# MEETING MINUTES

<b>MEETING NAME</b>	SPPL DD Meeting	<b>MEETING LOCATION</b>	SPPL Conference Room and Zoom
<b>MEETING DATE</b>	9 November 2023	<b>MEETING TIME</b>	12:00PM

**PROJECT NAME** Sun Prairie Public Library Remodel and Addition

**SITE REMOVALS**

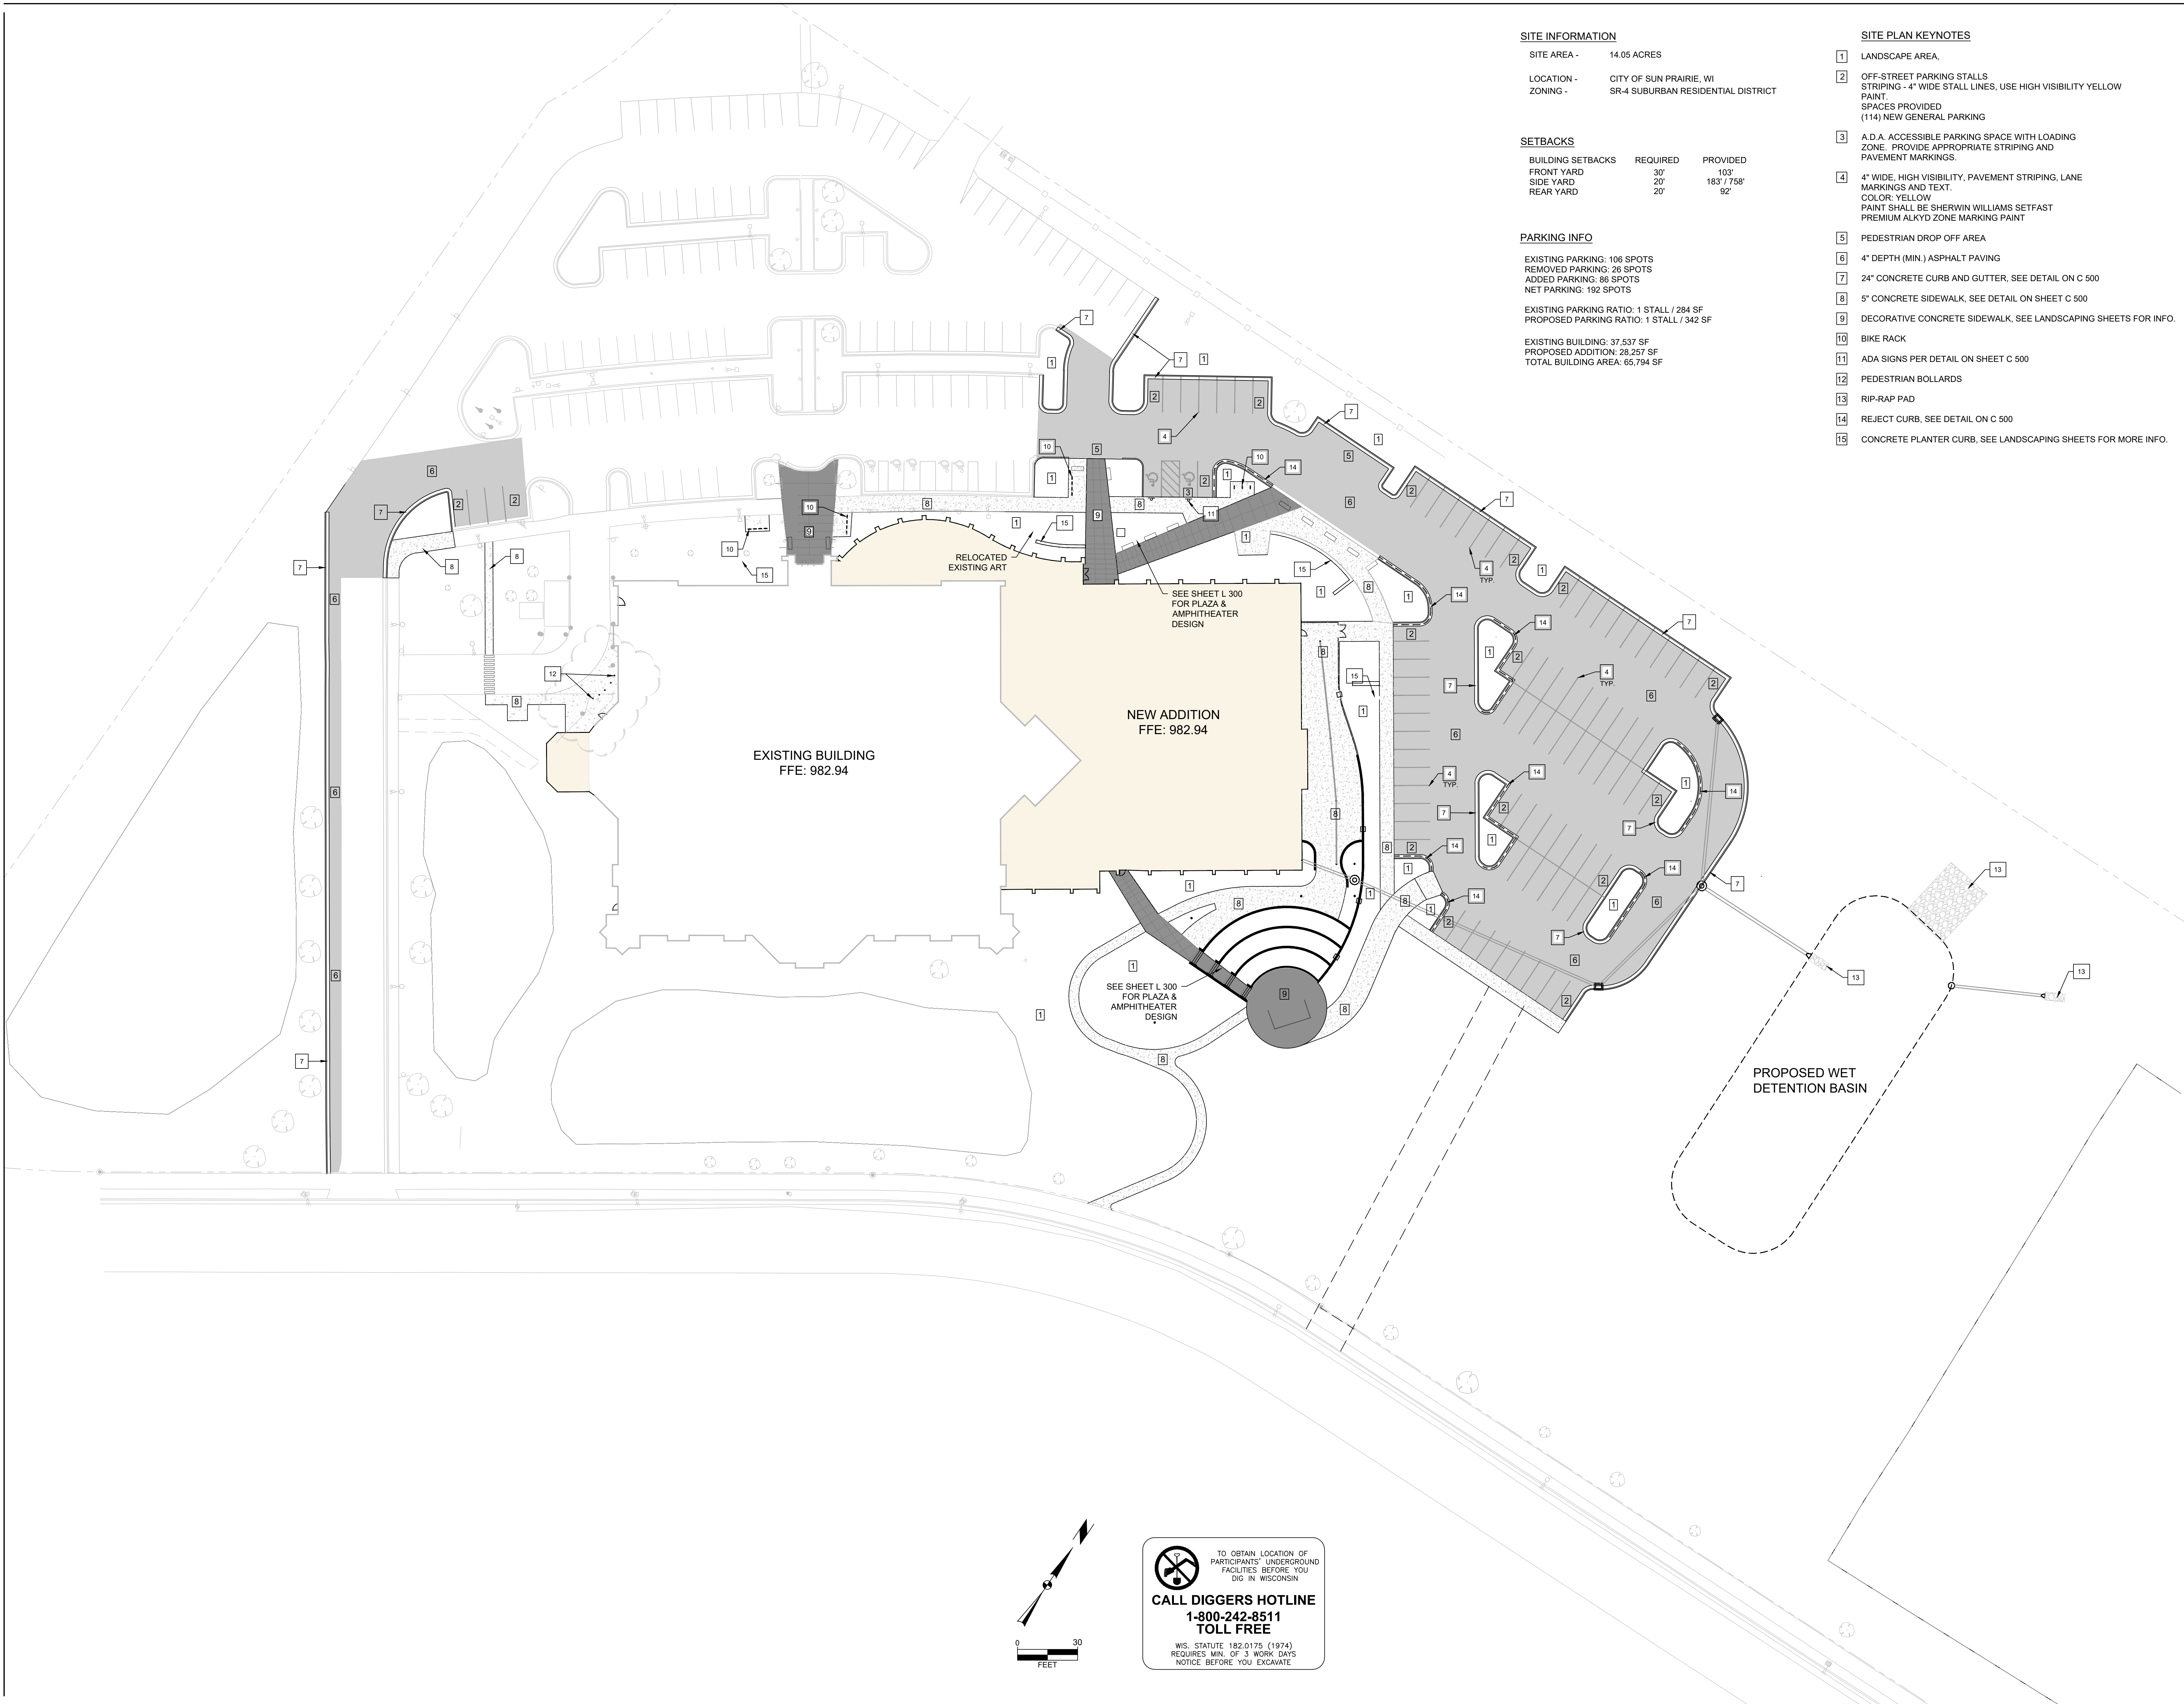
- l) There is a space to the west of the carport for a staff picnic table.
- m) The existing shed on the west side of the existing building should be removed as part of the project.

- q) It was suggested that the utility plan be shown on the landscape plan to identify potential conflicts.
- r) The existing sign to the media center should be removed and turned over to the media center.

- s) The existing awnings on the media center should be removed and do not need to be salvaged.

SHEET TITLE  
**SITE PLAN**

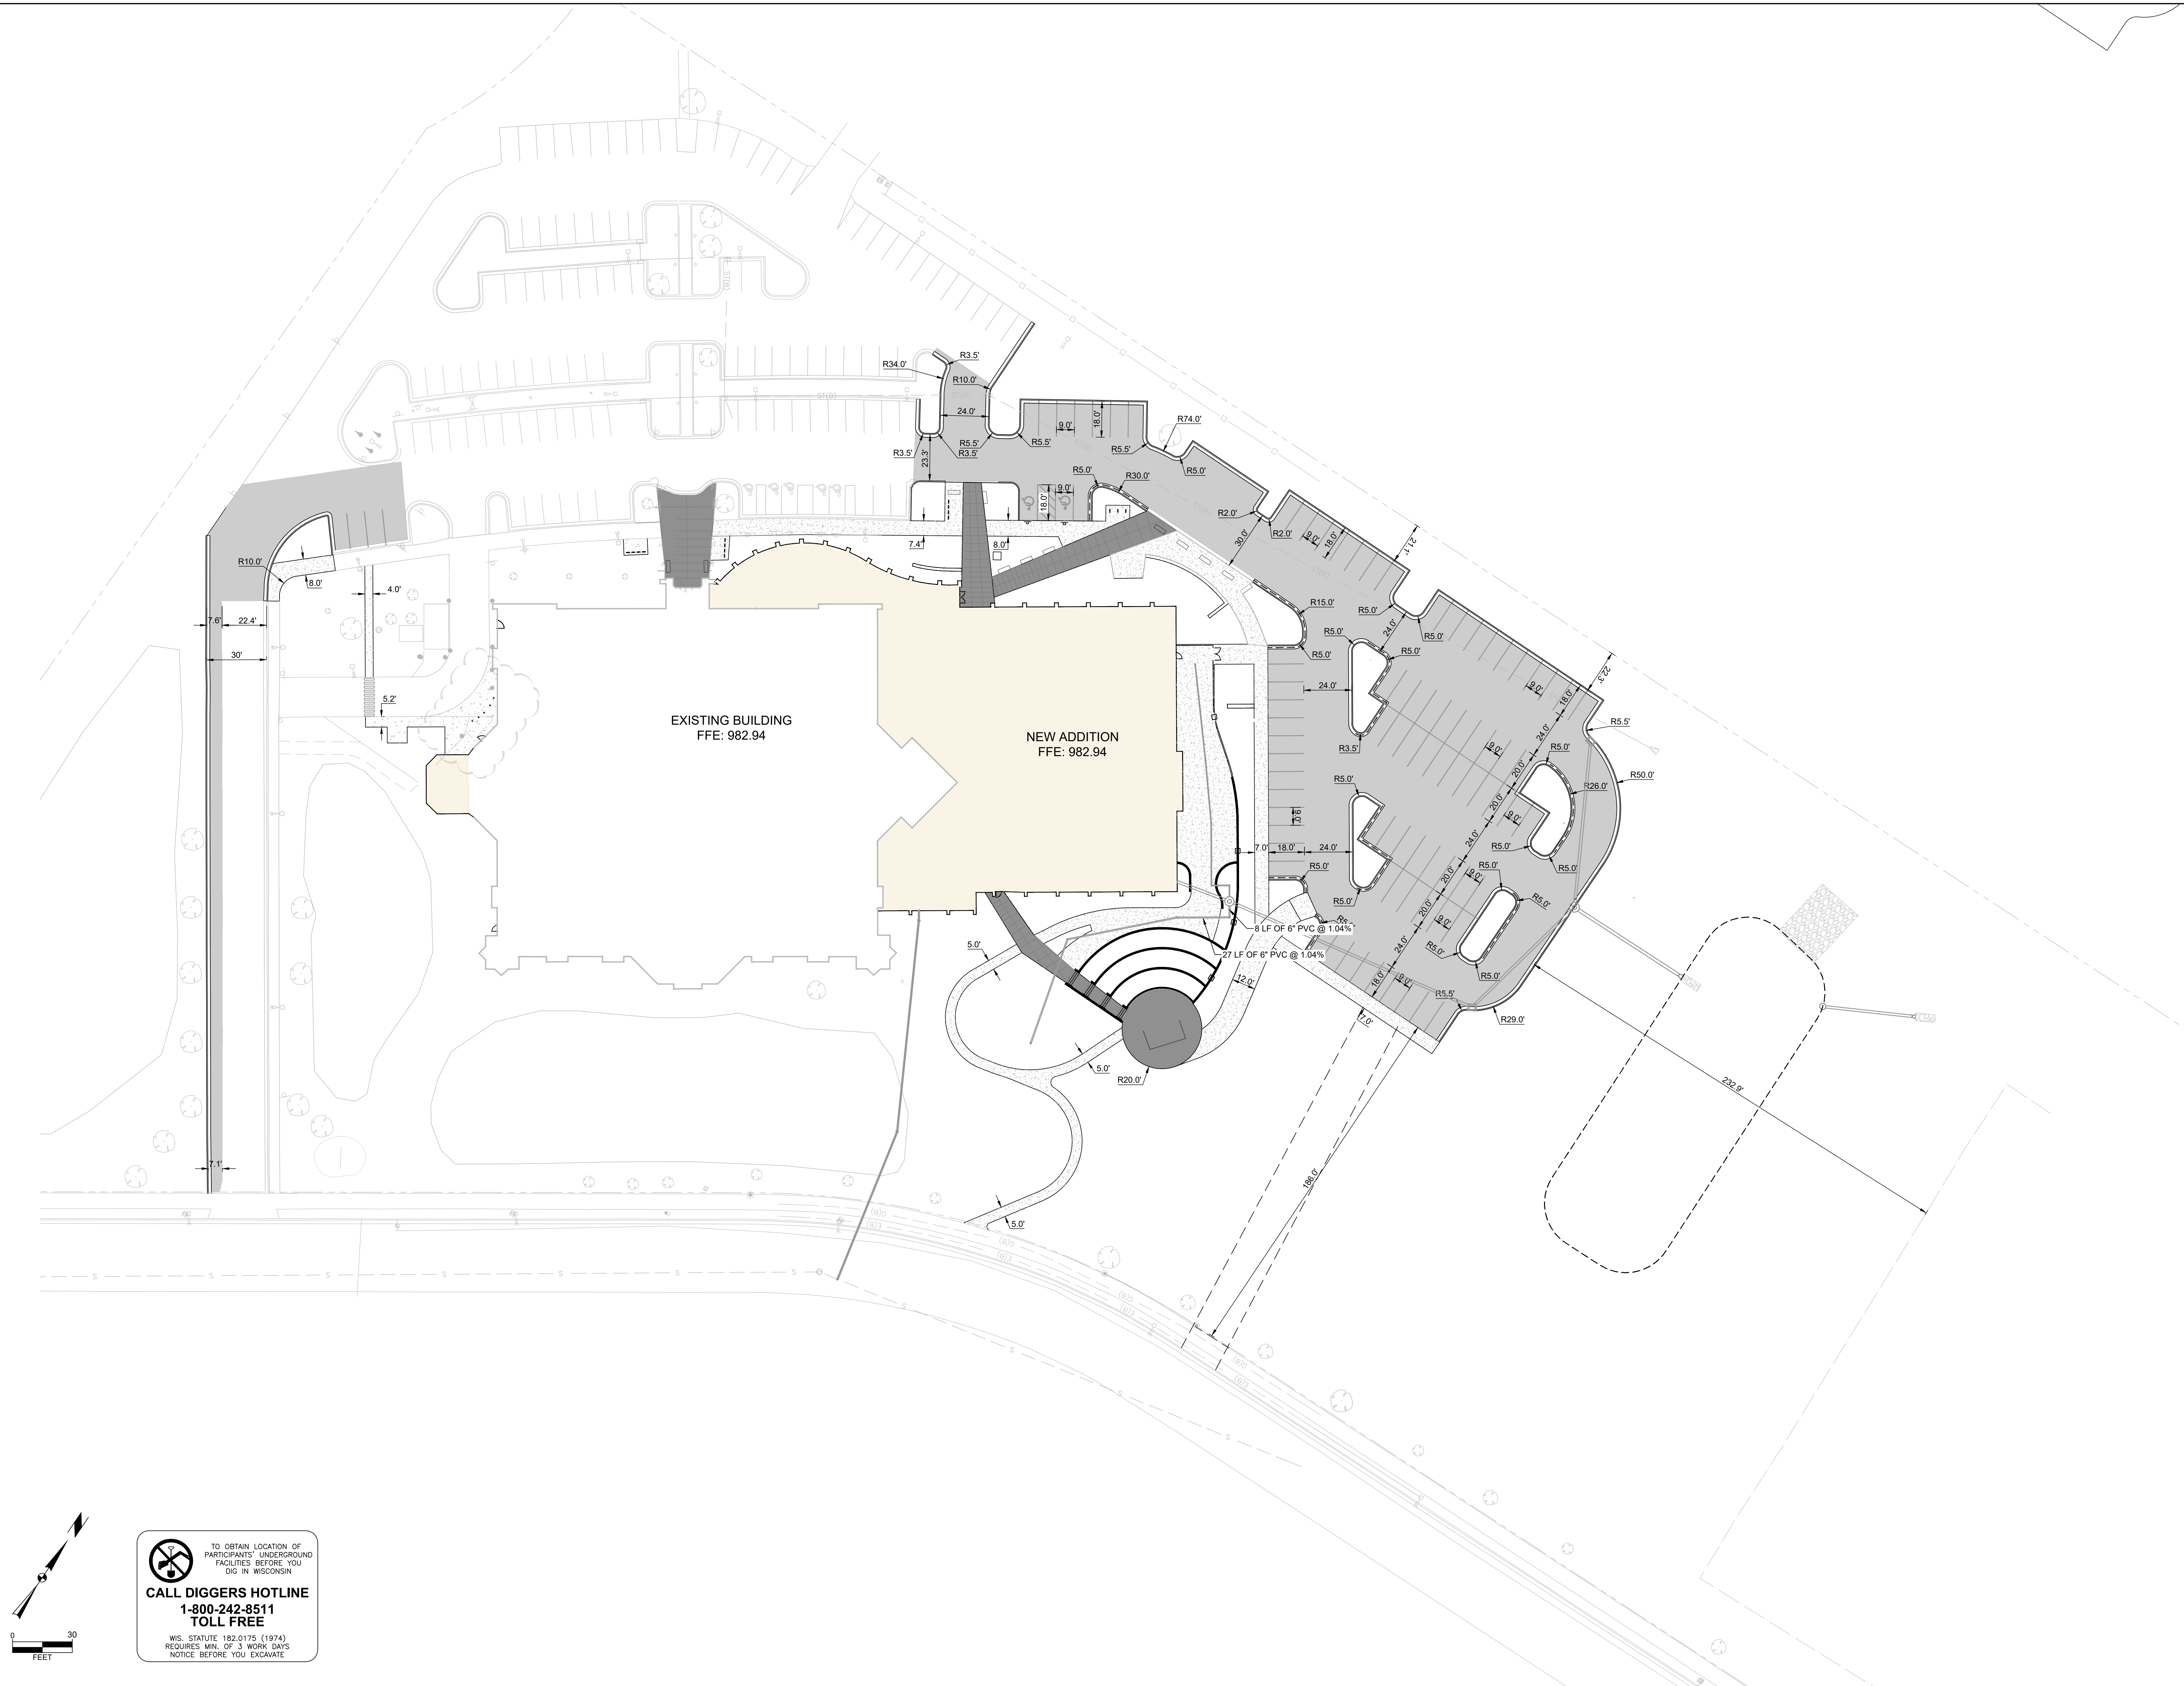
- d) It was requested to add a connection from the parking lot to the top level of the amphitheater at the south.
- e) A low wall at seat height has been shown at the drop off area to help with navigation. Low walls will have skate-stop.

- j) It was suggested that planters (bollards) be provided at zero-curb locations and stone benches be provided at the amphitheater.
- k) Bike racks were also requested at the sidewalk at Linnerud Drive near the sidewalk to the amphitheater.

- b) The site plan removes 26 existing parking spaces as part of the project and adds 86 for a net gain of 60 spaces.
- c) A temporary gravel road is being proposed for construction. The group was in favor of this plan to keep construction traffic and library traffic separate. Effort will need to be made to keep the sidewalk open at that location. Curb and sidewalk replacement should be planned at the temporary road.

- f) It was suggested that a removable bollard be provided at the center of the wide path to the amphitheater to prevent unwanted traffic.
- g) It was requested to soften the drainage slope east of the path from the parking lot to the amphitheater.

- h) EV charging quantities was discussed. Two dual chargers should be planned for now, near the existing ADA parking north of the existing building. Expansion to a total of five dual chargers should be anticipated, with the additional units located east of the addition.
